HOMESTEAD AT BRYAN FARM

CZ-MP-23-04

Town of Garner

Updates During Council Hearings

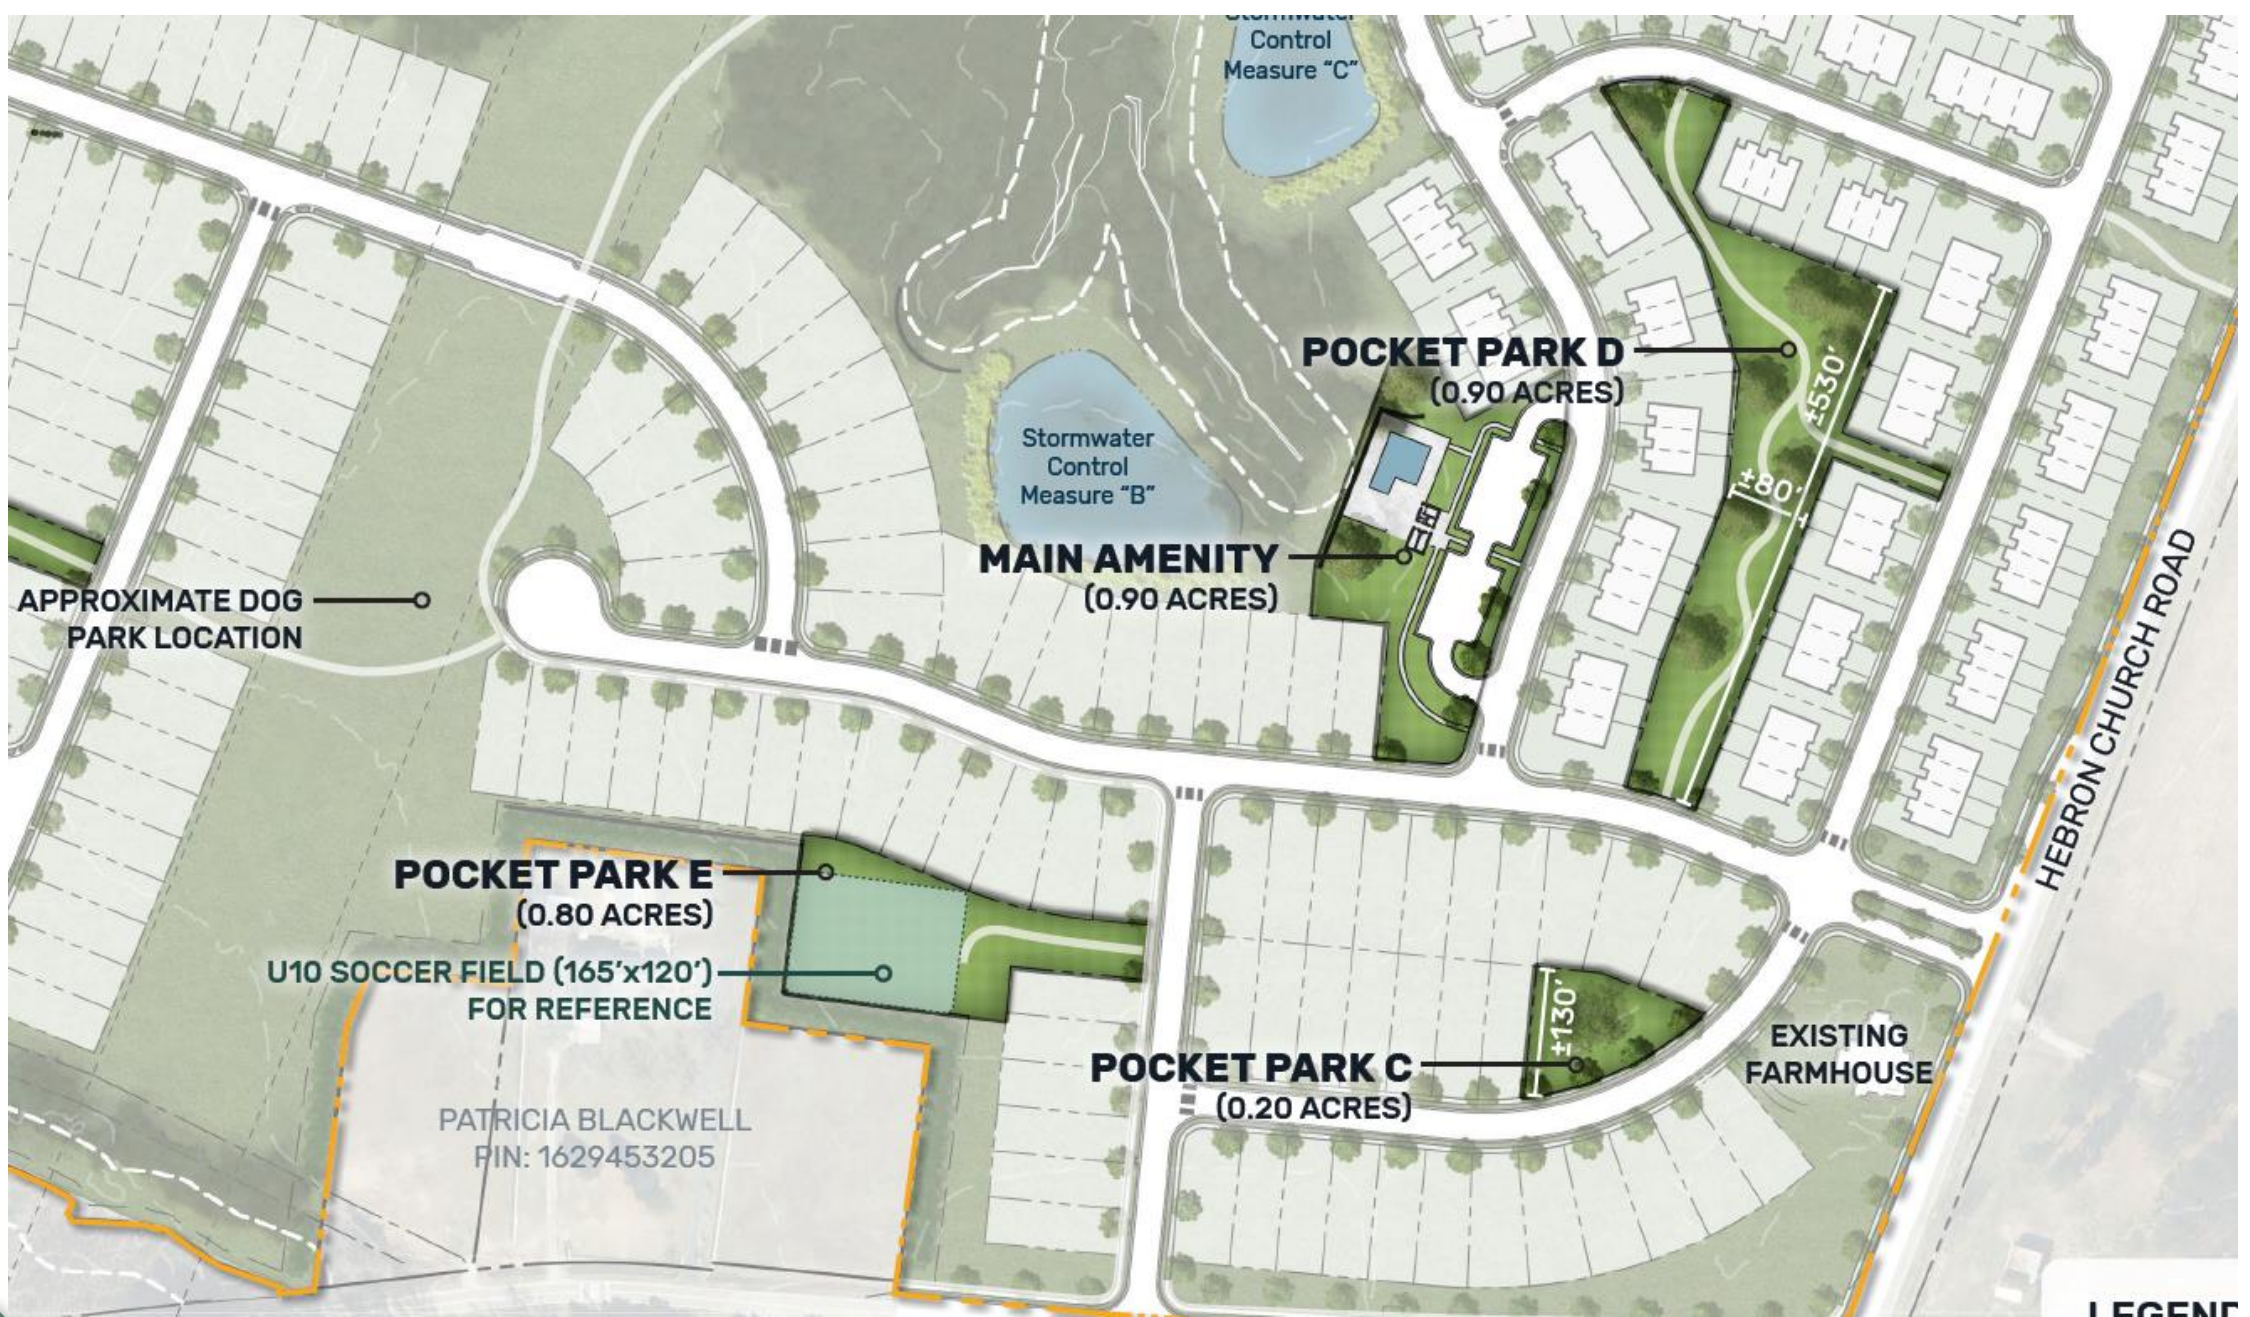
- Reduced density by 50 units (310 to 260 units)
 - Eliminated flexibility in final unit count
- Flipped ratio of townhome to single family detached
 - Previous plan: 70% townhomes (203) to 30% SFD (88)
 - Updated plan: 39% townhomes (102) to 61% SFD (158)
- Enhanced architectural conditions
- Enhanced greenway and sidewalk network
- Enhanced open space and amenity commitments

- Permitted uses: single family & townhouse
- Max of ~~310~~260 units
- HOA required
- Contribution to White Oak/Bryan Road corridor improvements
- Black aluminum picket fencing shall be provided around wet pond SCMs
- Amenities:
 - Main amenity shall begin construction upon receiving first CO for homes in Phase 1 and will be constructed within 18 months:
 - Pool (min 1,500 square feet), Cabana (min 800 square feet)
 - Each pocket park shall contain at least two of the following: benches, shade structure, playground, dog park, or paved walking trail
 - Minimum of 1 dog park required
 - Minimum of 1 playground required
 - Two play lawns with minimum 10,000 square feet area, bounded loosely by landscaping and/or hardscaping features such as trees, shrubs, benches, decorative fence sections, sidewalks, trails, or similar

- A covered front porch (minimum ~~20 square feet~~ 5' x 5') is required on all dwelling units. All entry areas must include 1 of the following: sidelights, transom windows, craftsman style paneling, glazing in the door.

- ~~Shutters or 1x4 window trim shall be provided on the front façade of all dwelling units and side facades of all townhome dwellings with right of way frontage.~~ All windows within a street facing facade face utilizing siding materials shall either be set in full trim at least equivalent to 1x4 board or feature decorative sills and pediments. All windows within elevations clad in brick or stone shall include masonry or decorative sill and lintels.

- A decorative light fixture (minimum 6 inch wide and 12 inch tall) shall be included on all garage door facades.
- ~~Articulation of the front facades of townhomes and/or an offset between units shall be provided to avoid flat building faces.~~ There shall be a minimum 2' front façade and 2' rear façade offset after every two units within a townhouse building.
